Work Order ID 148232

Item Name: Strut Bracket

APICAL INDUSTRIES, INC.	ENGINEERING CHANGE NOTICE NO. 03985			SHEET 1 OF 2	
	DWG NO. 647.0100	REV: A	PREPARED BY J. BECKER	DATE: 7/15/13	EFFECT ON DWG ☐ INC. ☒ UNINC.
	DWG TITLE: SHEET METAL				
	APPROVED BY: ENGR 	MFG 	QC 	EFF. NEXT ORDER	
TRANSACTION CODES (TC): A-ADD C-CREATE R-REVISE D-DELETE	REASON: REVISED NOTE 2. ADDED 647.0117

SHEET 1, ZONE D1 IS:

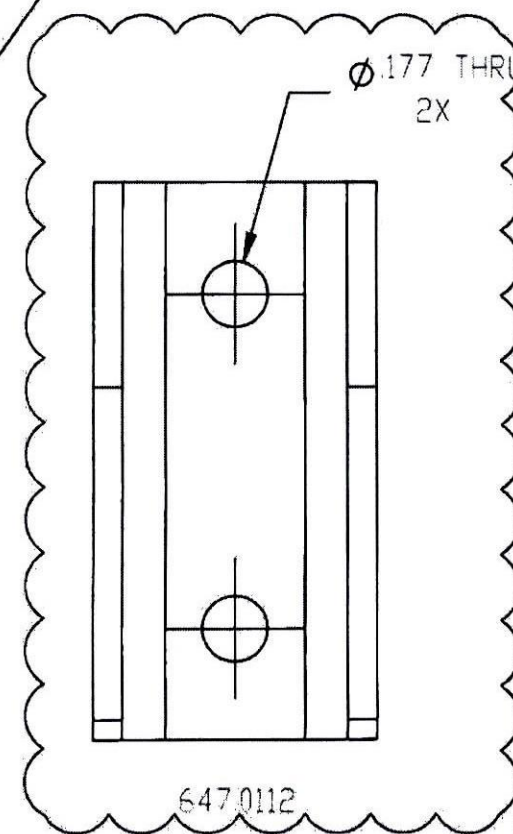
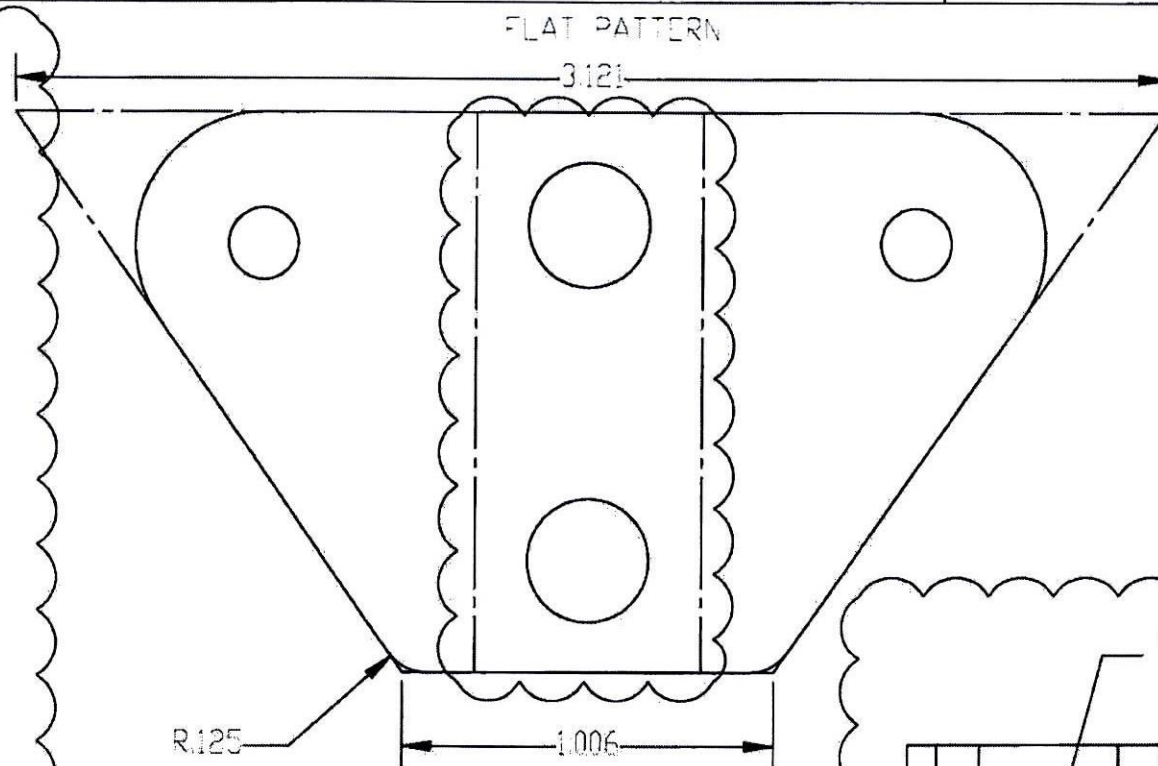
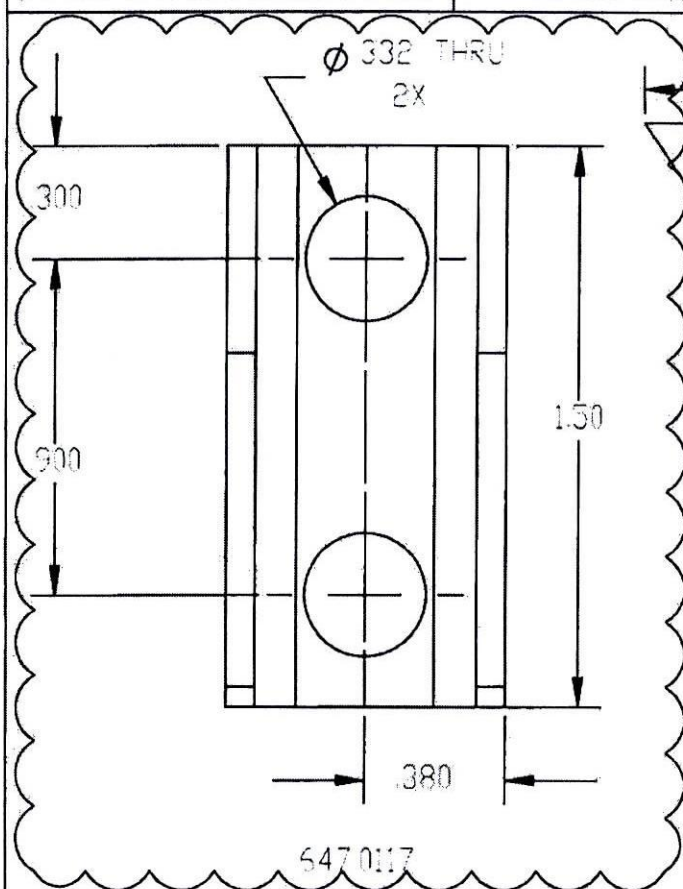
- 1 MATERIAL: ALUMINUM 2024-T3 PER AMS-QQ-A-250/4.
- 2 FINISH: IAW MPP-172 ANODIZE IAW SECTION 2.1, PRETREATMENT IAW SECTION 3.1 AND PRIMER IAW SECTION 4.1.
3. DEBURR AND BREAK ALL SHARP EDGES.
4. IDENTIFY IAW MPP-120.
- 5 MATERIAL: 304 SS IAW AMS 5643.
- 6 FINISH: PRIME IAW MIL-P-23377J TYPE I CLASS N.
- 7 OTHER DIMENSIONS SAME AS 647.0112.

C	647.0117	STRUT BRACKET		△	△
F/N TC	PART NUMBER	DESCRIPTION	MATERIAL	SPECIFICATION	
DOCUMENTS EFFECTED:			CHANGE CATEGORY	DER REVIEW REQUIRED	
☐ MDL ☐ INSTALL INSTRUCTIONS ☐ ICA ☐ FMS ☐ BOM			☐ MAJOR ☒ MINOR	☐ YES ☒ NO
